January 17, 2019

**Re: Response to the NRC's Letter Dated December 20, 2018 regarding RbM
Services, LLC, Request for Additional Information
[CONTROL NUMBER 610517]**

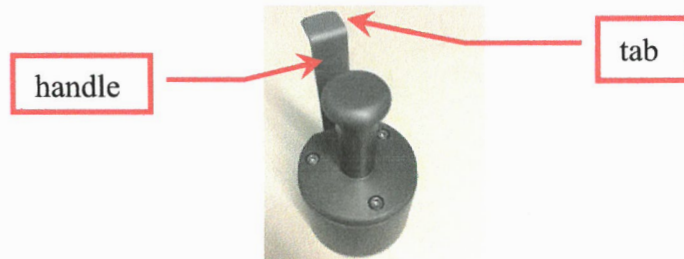
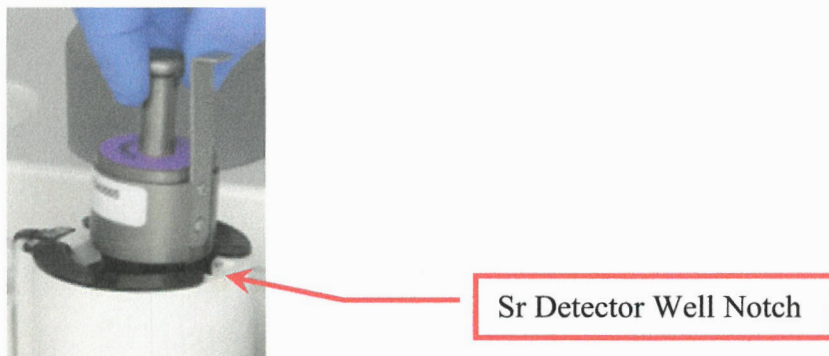
2. In order for the NRC staff to determine whether the Na-22 sources can be authorized under 10 CFR 32.18, we need to know the details of the mechanical holder that you described as "designed to provide the correct geometry."

Specifically, does this mechanical holder contain any mechanism that moves or positions the Na-22 source when the holder is inserted into the CardioGen-82 infusion system?

Stated another way, does the holder contain any parts or mechanisms that are activated by the user or by the system into which it is inserted?

The same mechanical holder is used for all of the Na-22 sources (10 μ Ci, 0.6 μ Ci, and 0.04 μ Ci). The source is placed/assembled, following a controlled manufacturing process instruction procedure, inside of the mechanical holder, which includes ensuring that that the source disk seats completely flush inside the mechanical holder's base.

The mechanical holder has a handle with a tab.

The end user places the mechanical holder into the Strontium Detector Well of the CardioGen-82 infusion system and aligns the handle's tab with the positioning notch on the well.

The purpose of this alignment/positioning is so that the handle is at the top of the well and pointing upward (i.e. the Na-22 source is at the bottom of the well and not at the top) and that the mechanical holder is parallel and flush with the bottom of the well (i.e., the Na-22 source is not at an angle with the bottom of the well).

This is necessary to maintain the same geometry of the Na-22 source to the Sr/Gamma detector when this detector takes its readings.
